Arborfield Green District Centre

Detail Sheet 4 - Balcony Type 2

SCALE	DATE	DRAWN	CHECKED
1 : 10 @ A0	05/06/25	MN	MB
PROVISION	DRAWING NO.	PROVISION	PROVISION
22585	BLK-6.30.203	P1

NSD - Balcony Type 2 Elevation
Scale 1 : 10

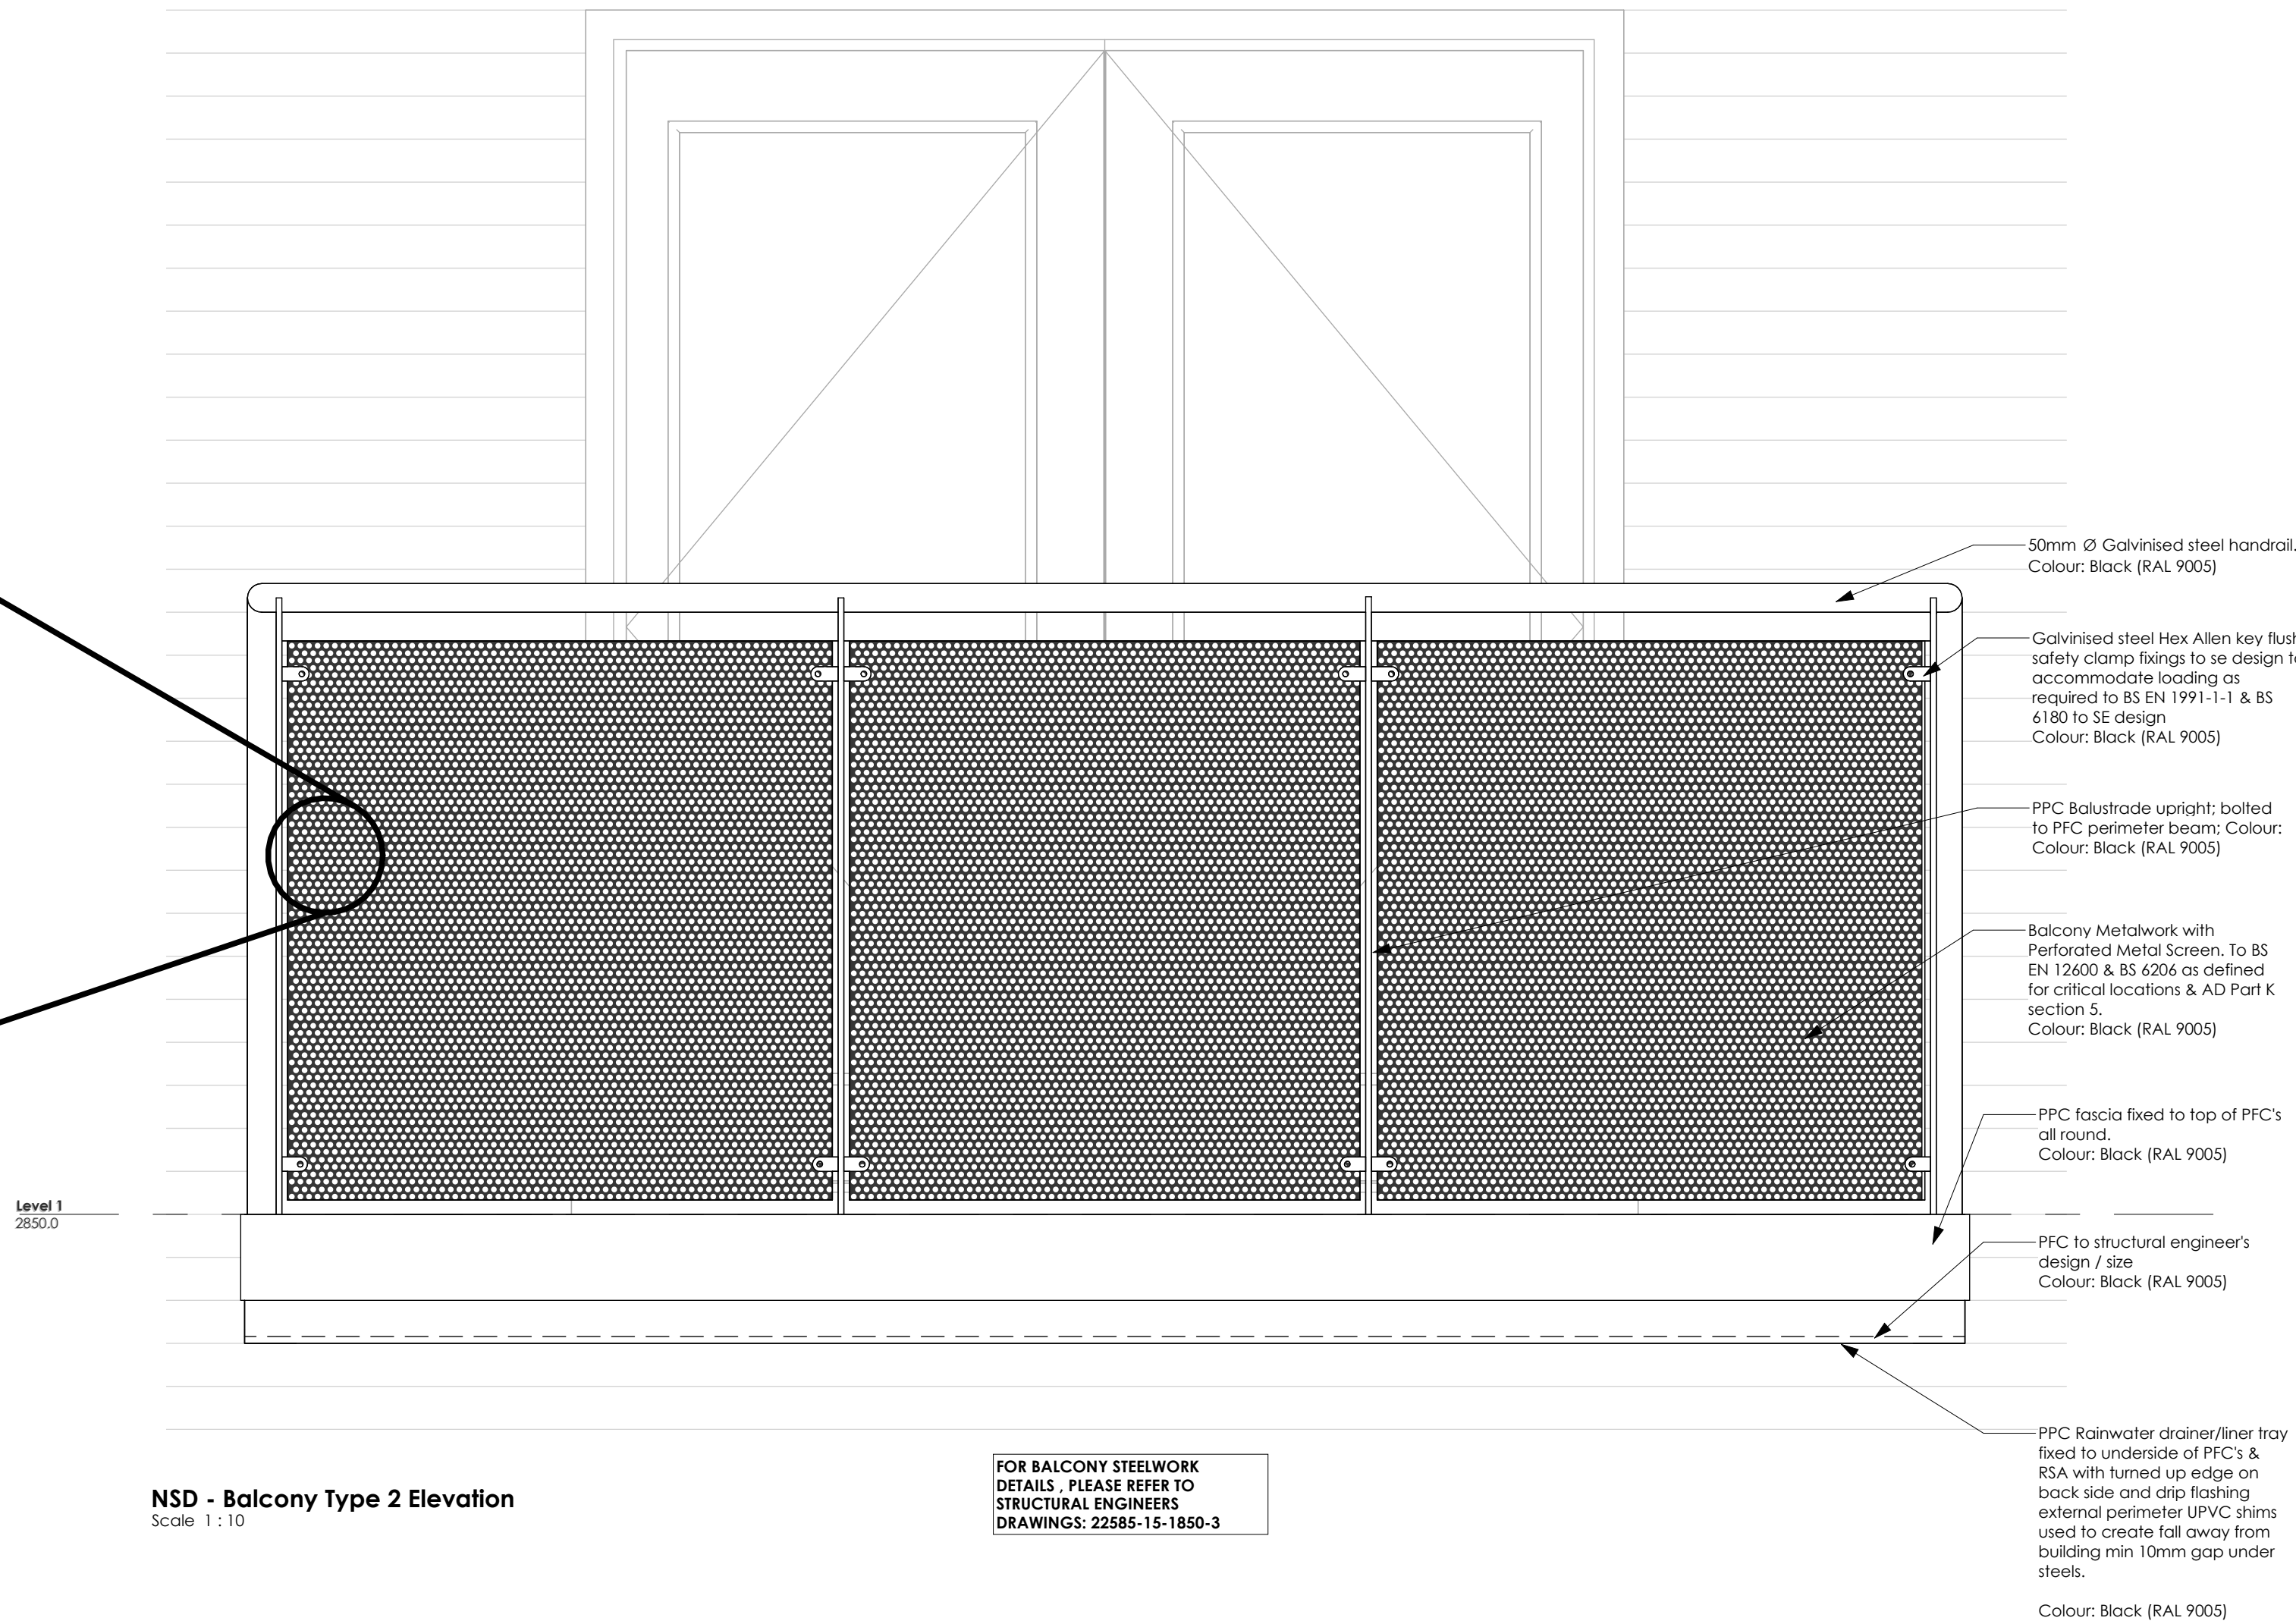
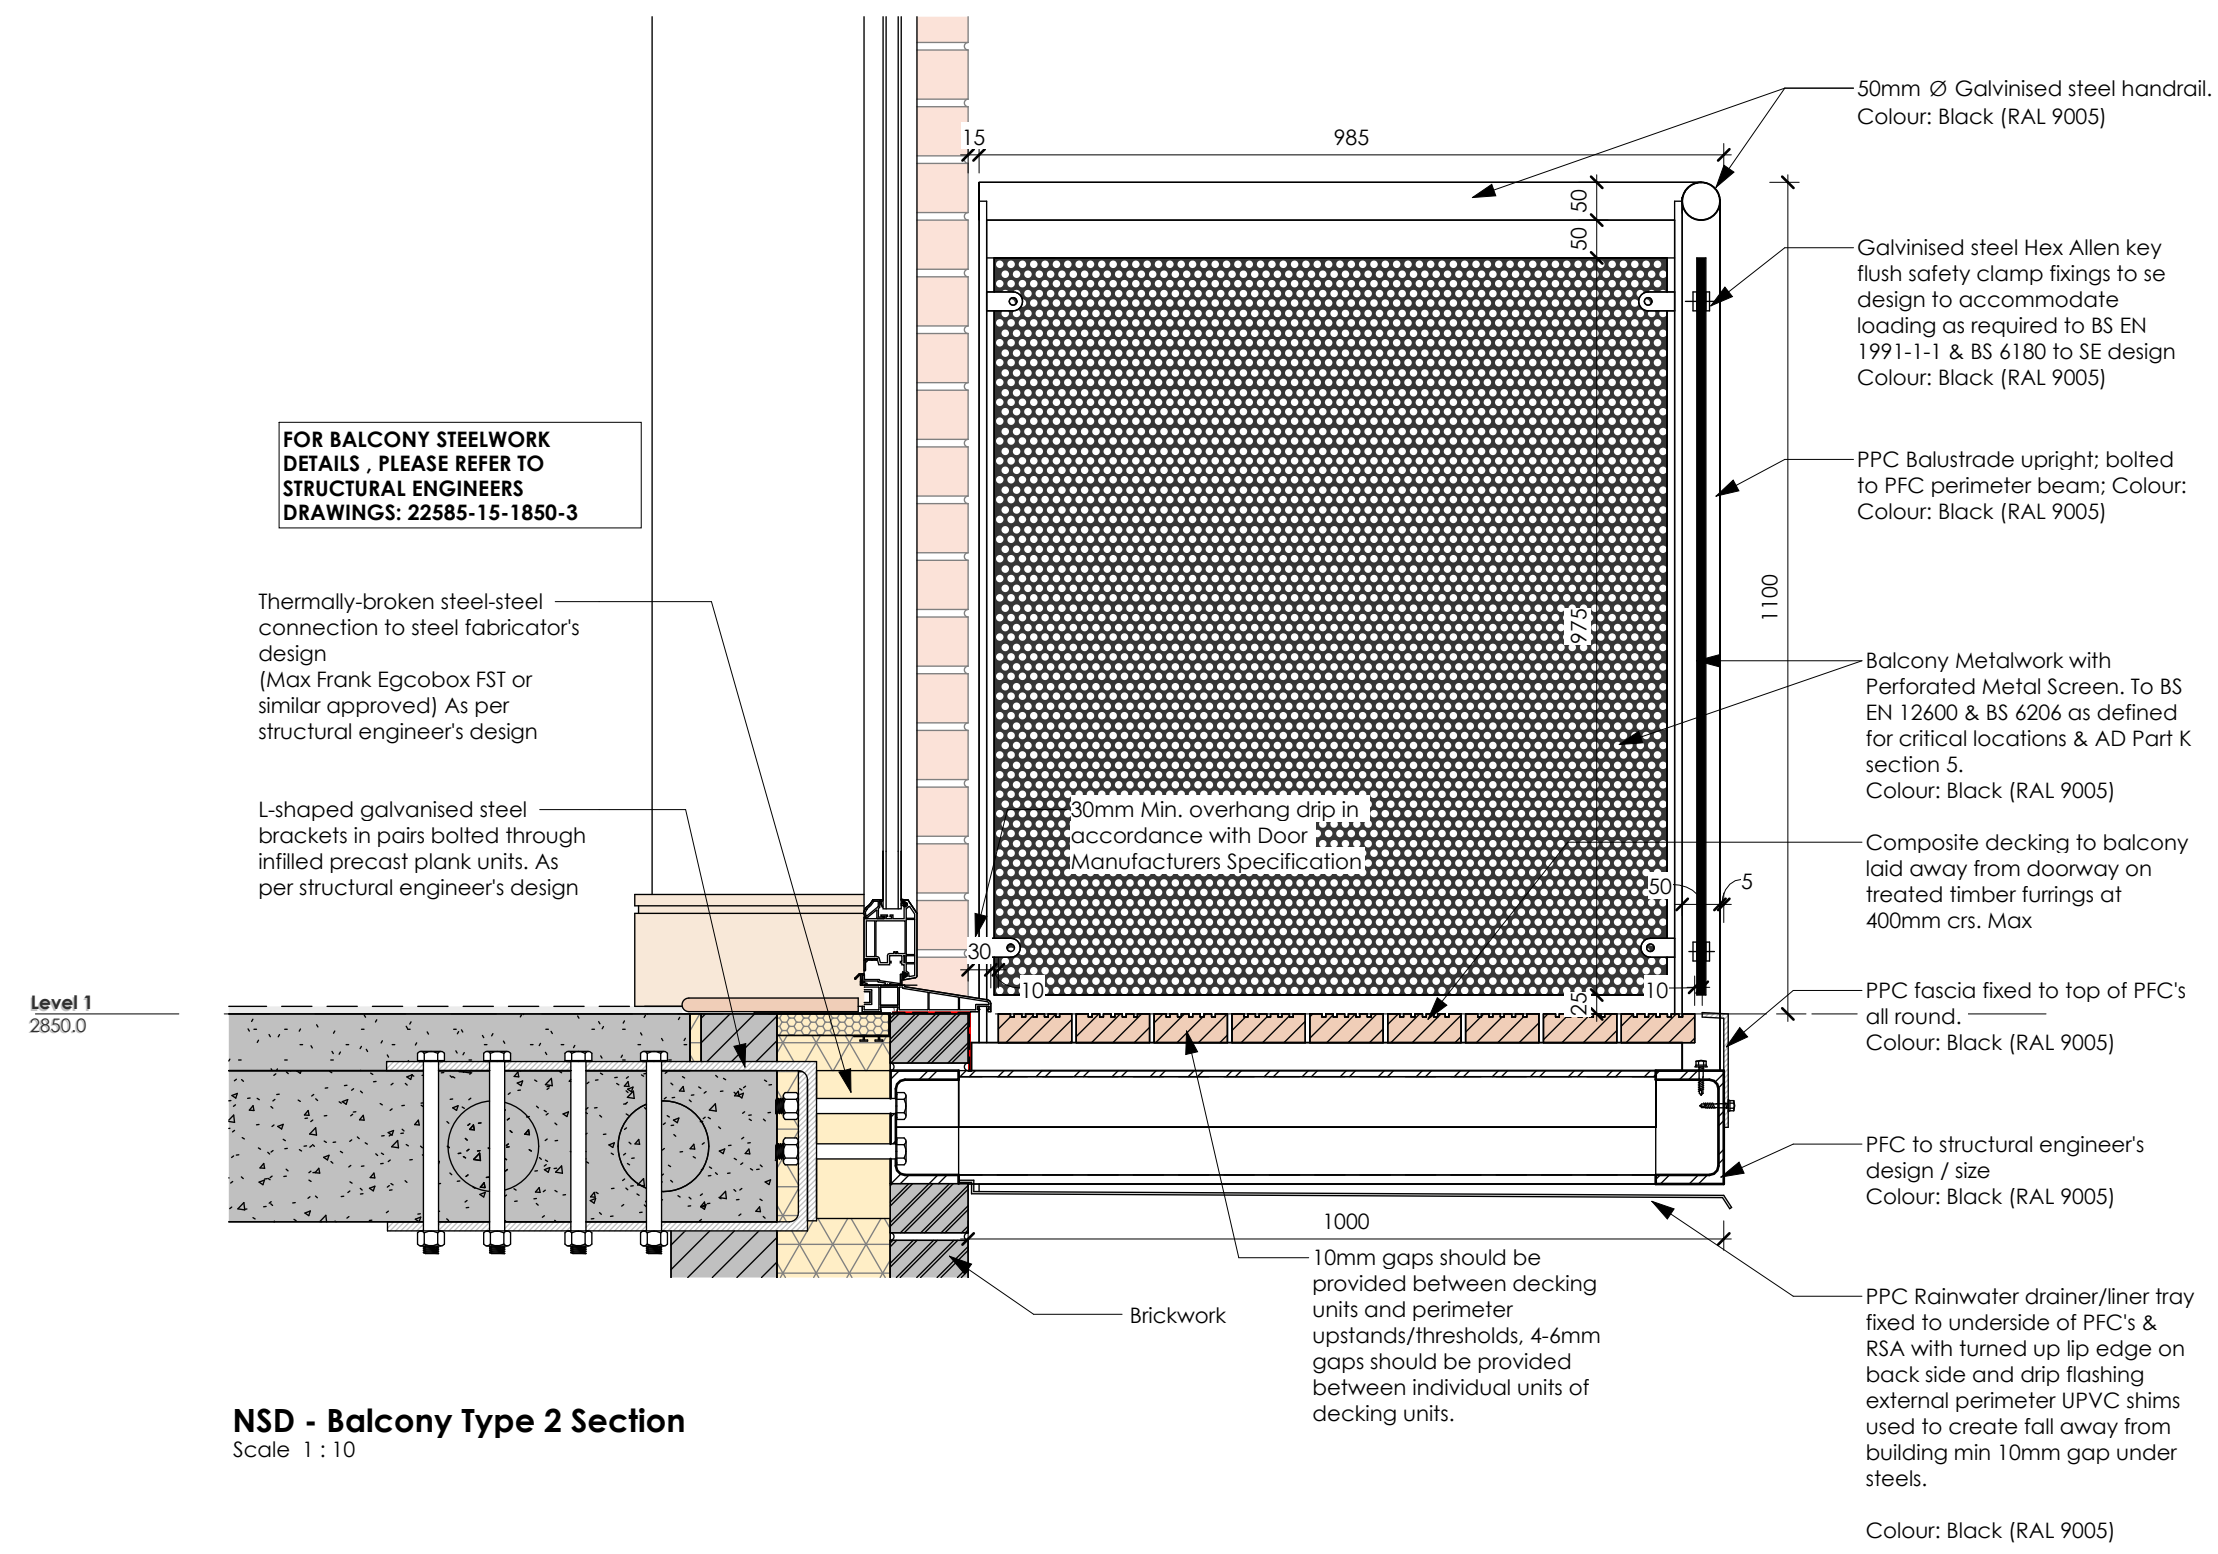
Rev	Description	Date
P1	Balcony metalwork updated. Glass baluster changed to metal perforated panel.	24.05.2025
